1997 - 1999 Corvette: Service Bulletin: Accessory Drive Squeak (Replace Idler Pulley)

Subject: Technical - Accessory Drive Squeak (Replace Idler Pulley)

Number: 99-06-01-007

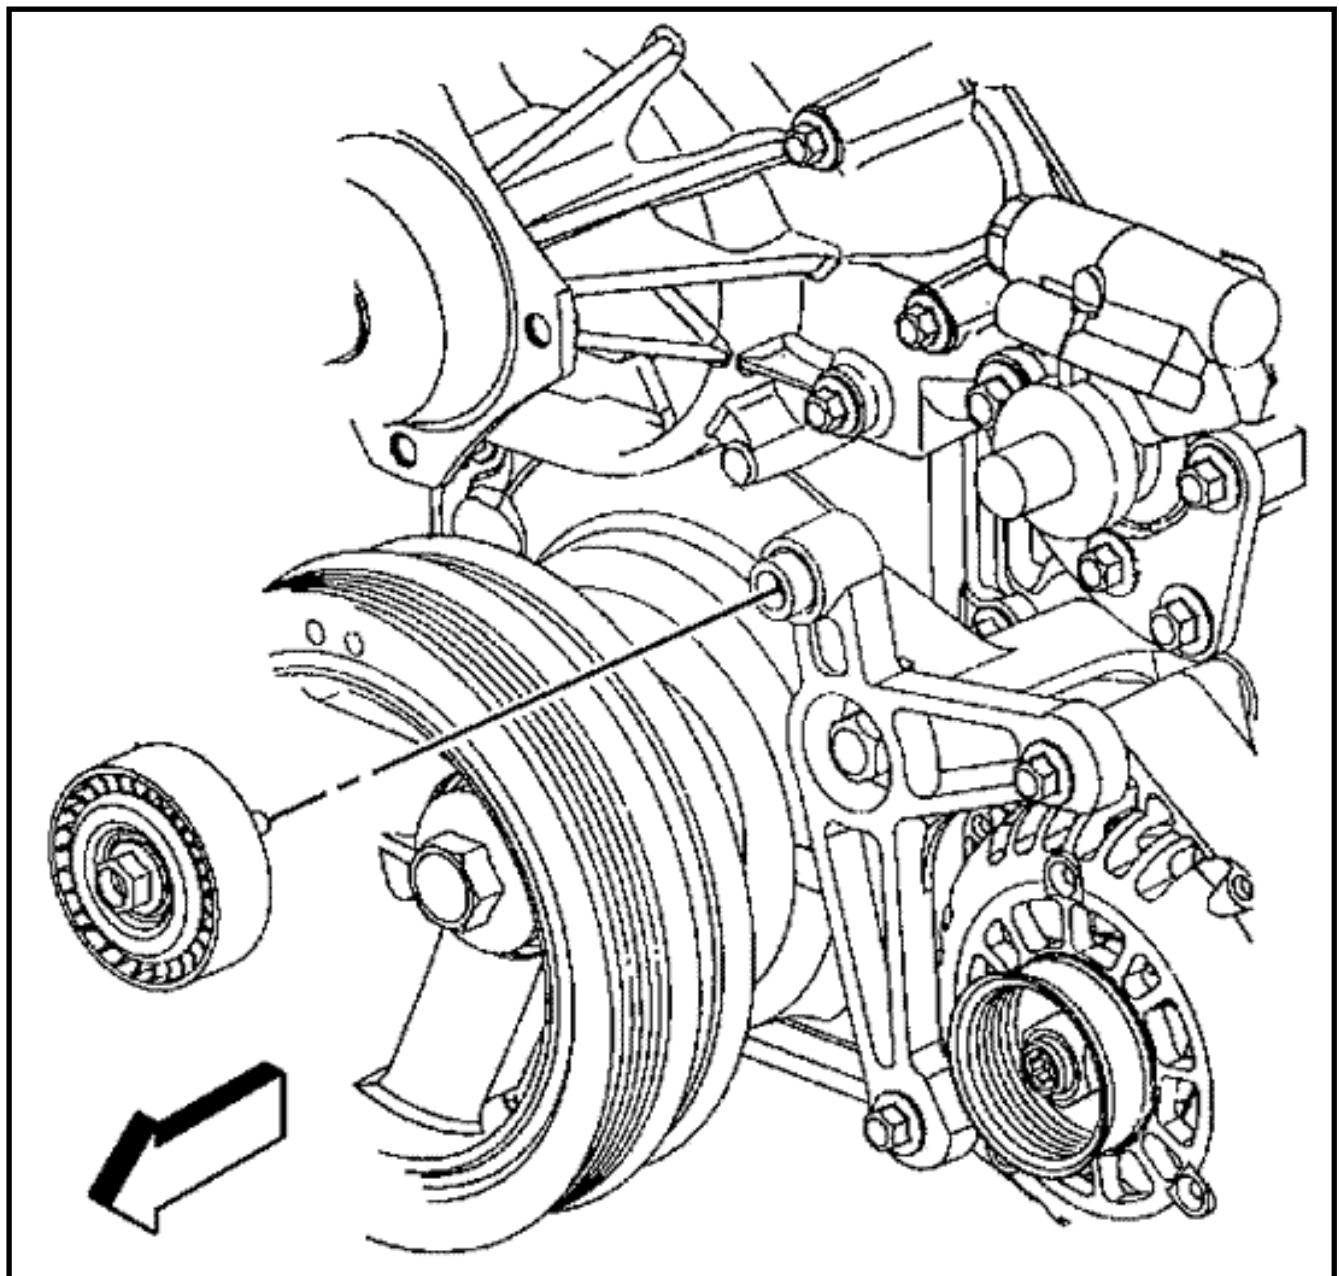
The idler pulley dust shield may distort during assembly due to torquing of the mounting bolt. This distortion may cause the idler pulley dust shield to contact the bearing race and the pulley resulting in the squeak noise.

A new idler pulley assembly is available with a thicker dust shield to prevent the distortion of the dust shield. The previous dust shield thickness is 0.61 mm. The new dust shield thickness is 1.37 mm.

- **Do not over-torque the mounting bolt or the condition may reoccur.**
Do not use pneumatic or electric tools for installation of the idler pulley assembly.

Torque the idler pulley bolt to 50 N·m (37 lb ft).
